# Technical Service Bulletin

## 20 Noises from the fuel line

20 23 53 2059997/4 January 31, 2023. Supersedes Technical Service Bulletin Group 20 number 21-37 dated September 30, 2021, for reasons listed below.

**Figure 1.** Location of the vibrating fuel line.

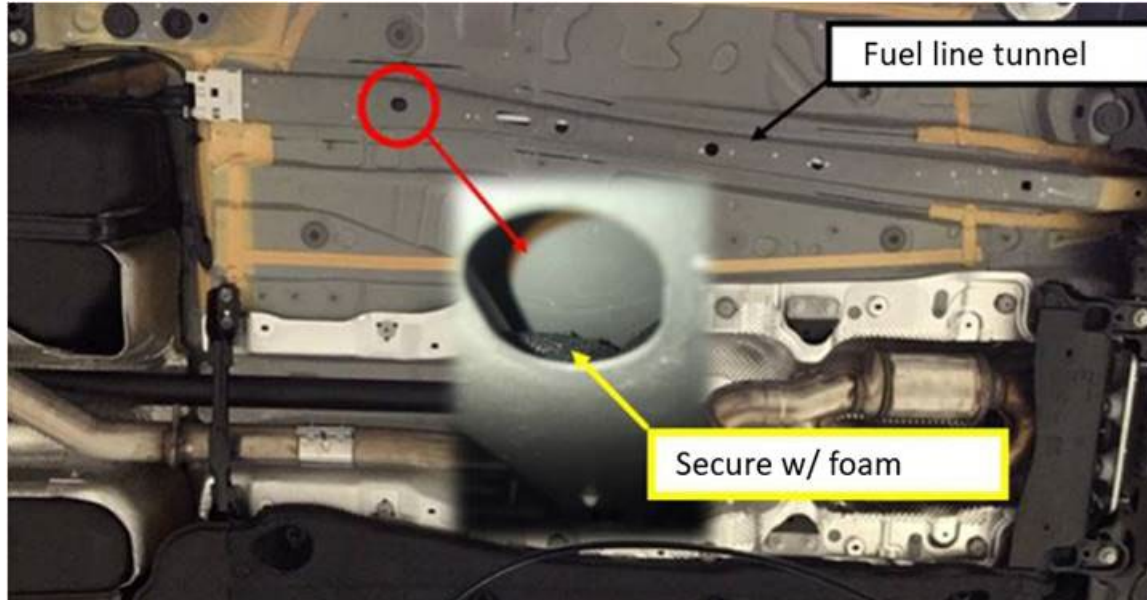
The fuel/EVAP lines in the longitudinal member start to vibrate in certain operating situations and this creates the noise.

Due to pressure pulsation from the high-pressure pump on engine side the underfloor line in the underbody tunnel vibrates. This vibration causes noise that can also be heard in the vehicle interior.

- Coat the fuel and EVAP line tunnel or fill the space around the fuel and EVAP line with closed-pore foam (foam that doesn't soak up water) part number 321 201 299. This means the fuel/EVAP line does not have to be removed.
